Exhibit B

License Amendment Request Dated June 22, 1987

Docket No. 50-263
License No. DPR-22

Exhibit B consists of marked up pages for the Monticello Nuclear
Generating Plant Technical Specifications showing the proposed changes as
listed below:

Figure 3.4-1 Sodium Pentaborate Solution Volume Concentration Requirements

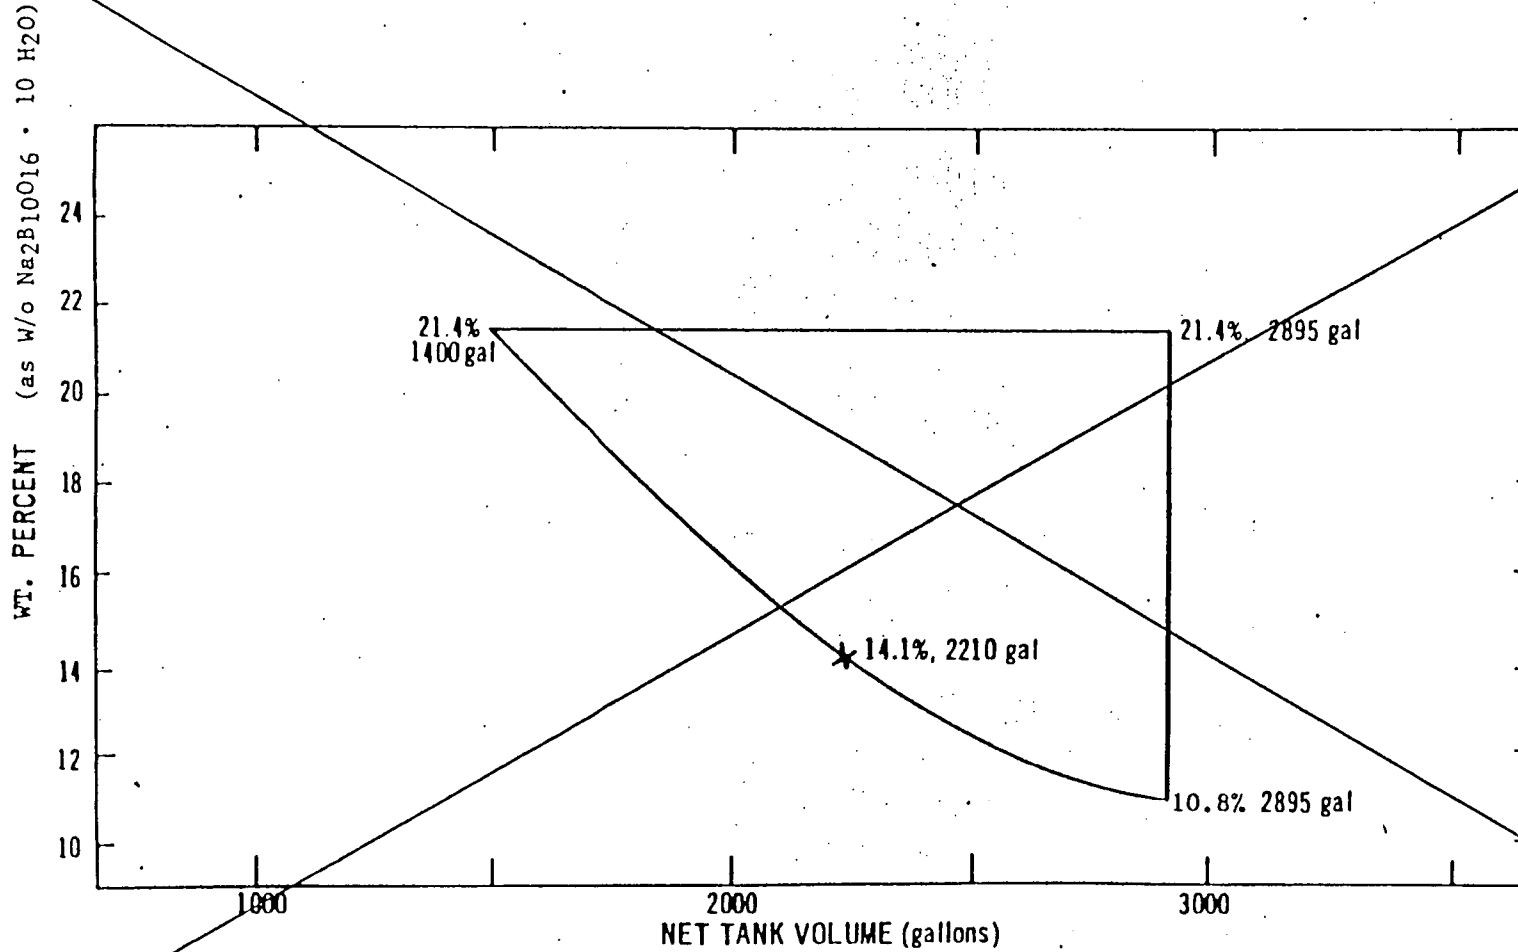
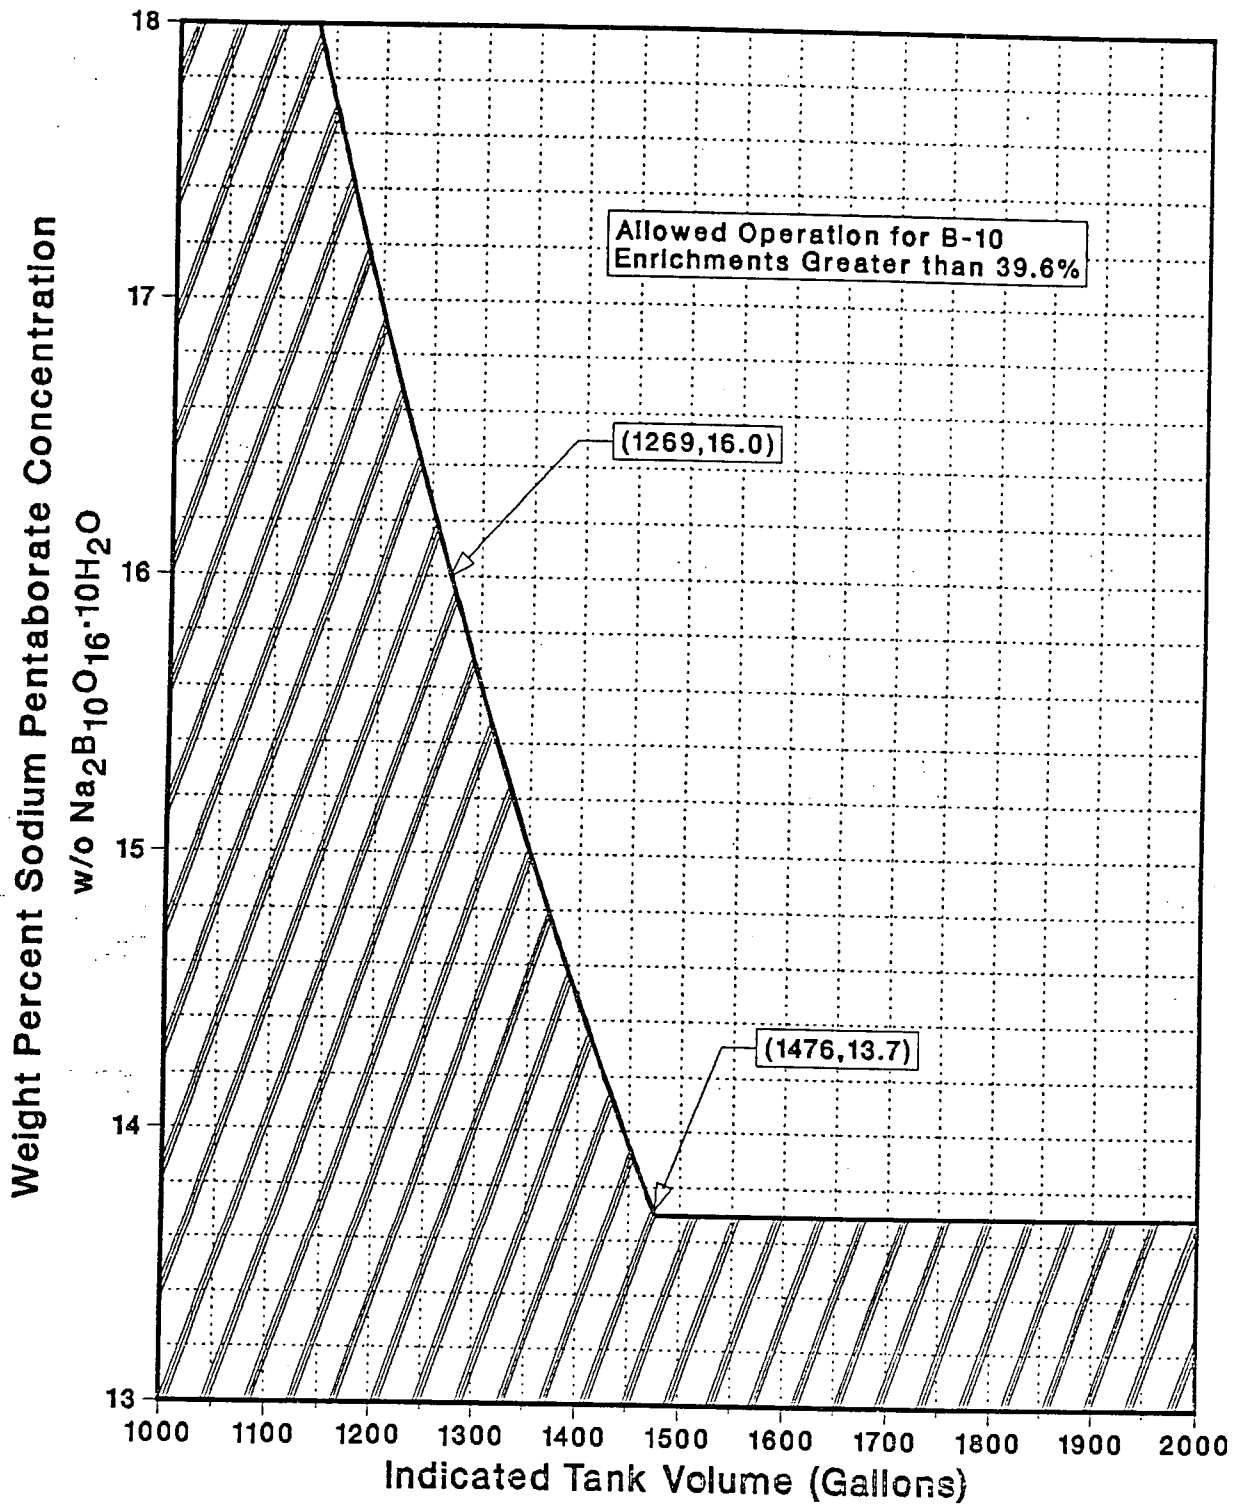
~~The liquid poison tank shall contain a boron bearing solution that satisfies the volume-concentration requirements of Figure 3.4.1 and at all times when the standby liquid poison system is required to be operable the temperature shall not be less than the solution temperature presented in Figure 3.4.2. In addition, the heat tracing on the pump suction lines shall be operable whenever the room temperature is less than the solution temperature presented in Figure 3.4.2.~~

1. The liquid poison tank shall contain a boron bearing solution that satisfies the volume, concentration, and enrichment requirements of Figure 3.4.1, or compliance can be demonstrated by satisfying the following equations:

Figure 3.4-2 Sodium Pentaborate Solution Temperature Requirements

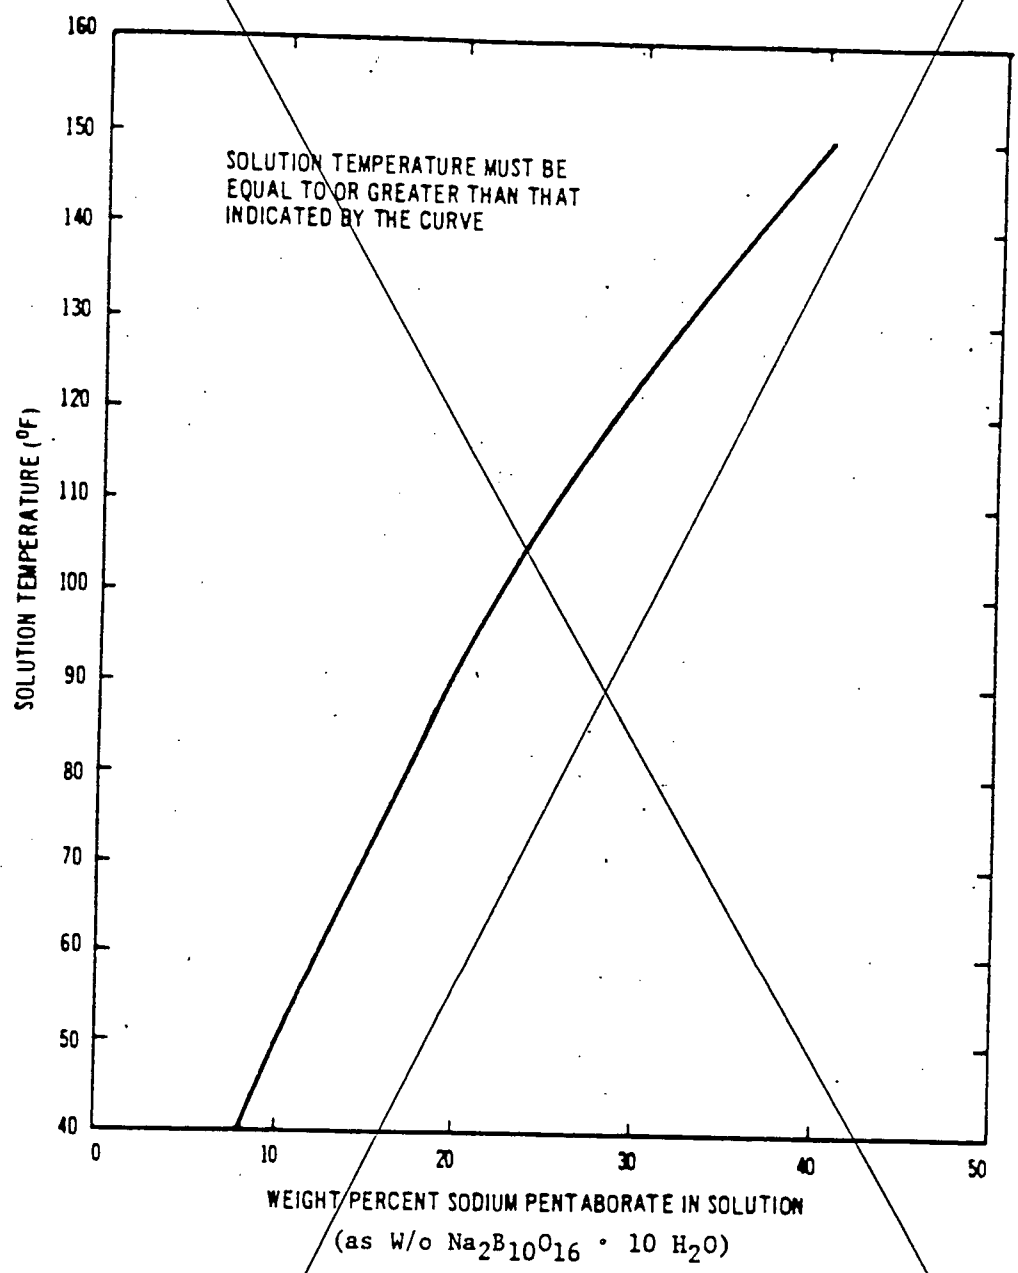
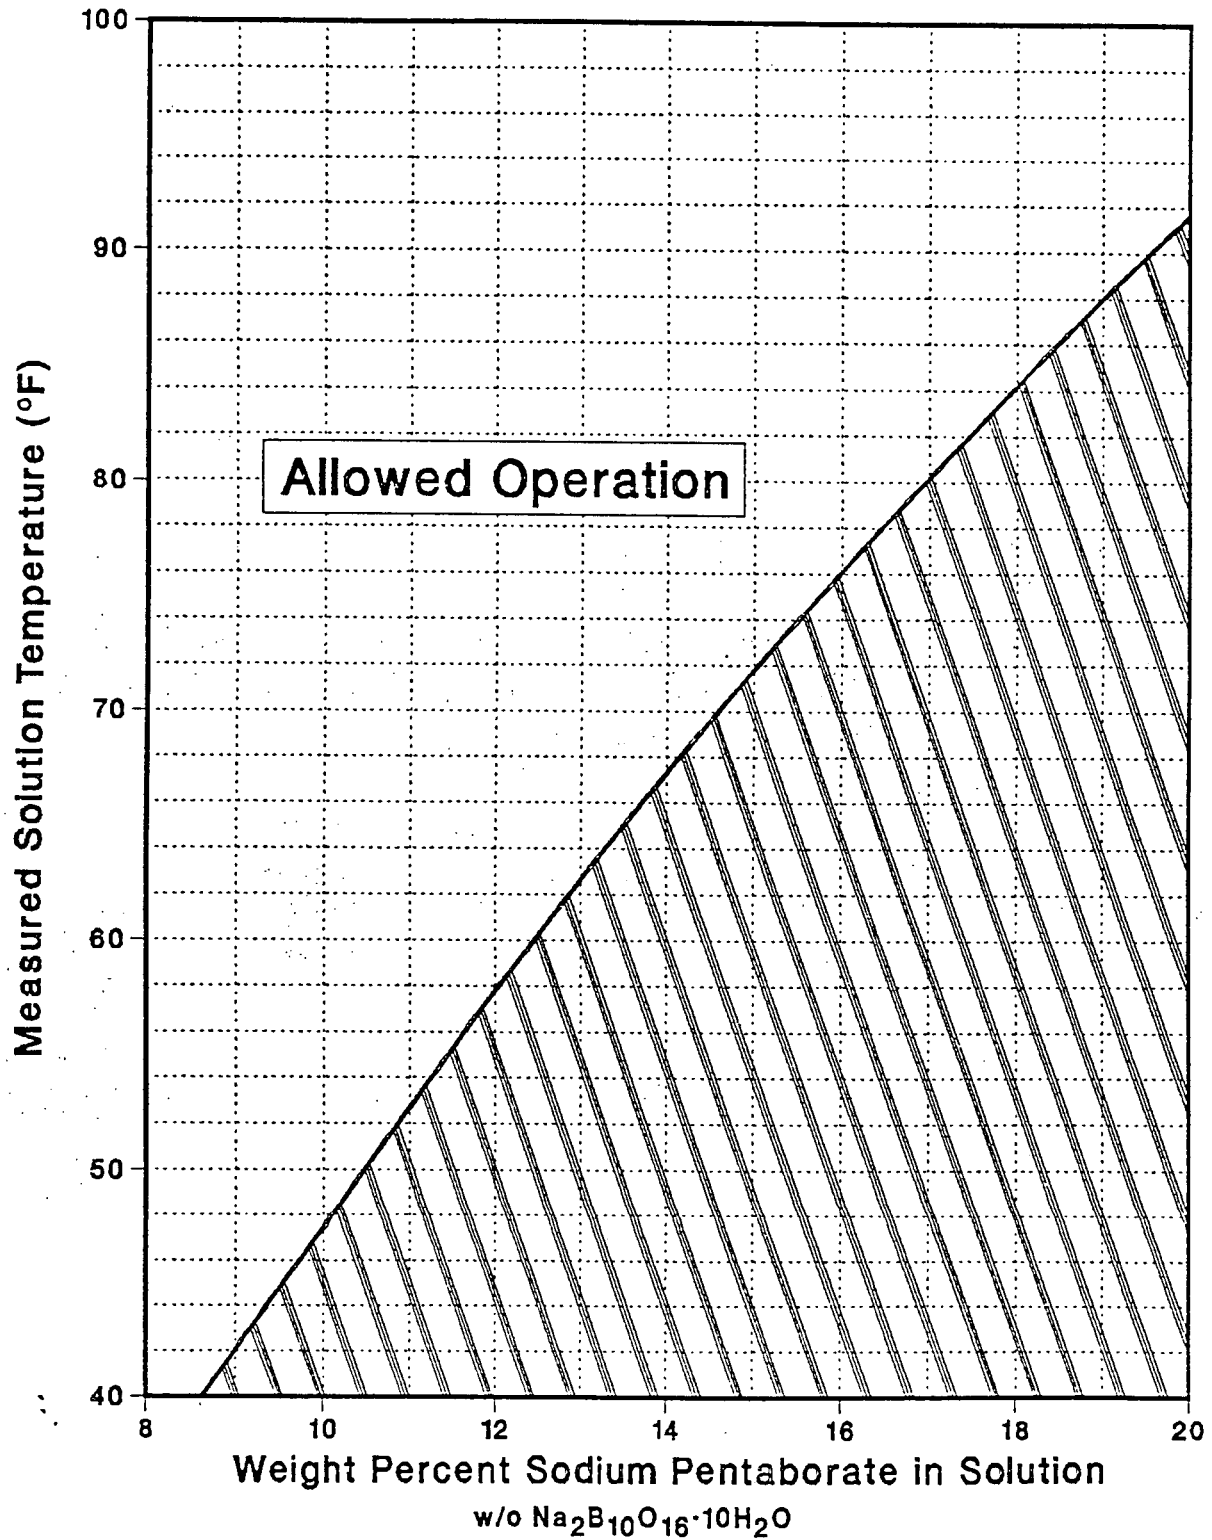
2. The temperature shall not be less than the solution temperature presented in Figure 3.4.2.
3. The heat tracing on the pump suction lines shall be operable whenever the room temperature is less than the solution temperature presented in Figure 3.4.2.
